Access Compliance Report

Public Rights-of-Way

(Pedestrian Signals)

Intersection ID: N/A	Main Street:	Cross Street: N/A	Location: N/A
ADA ID: ED3BB473F773	Signal Type: One Push Button-Non APS	Overall Compliance: No	Severity Score: BTN 1: N/A BTN 2: N/A No BTN: N/A
Codes/Mitigation Info/Possible Solution		Field Measurements/Component Compliance

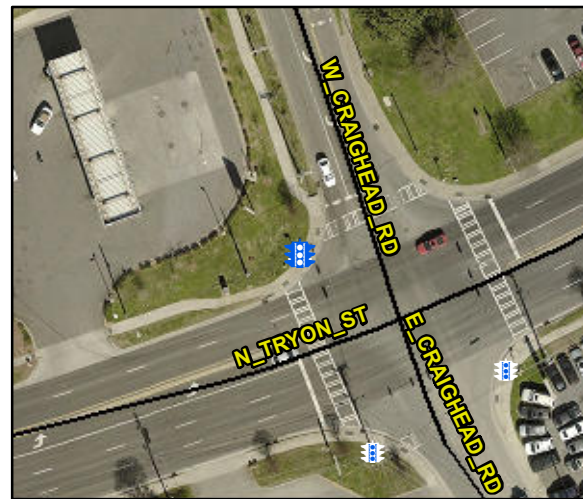
PROW/ADA: R406.2

Possible Solutions: Provide Push Button Extension.
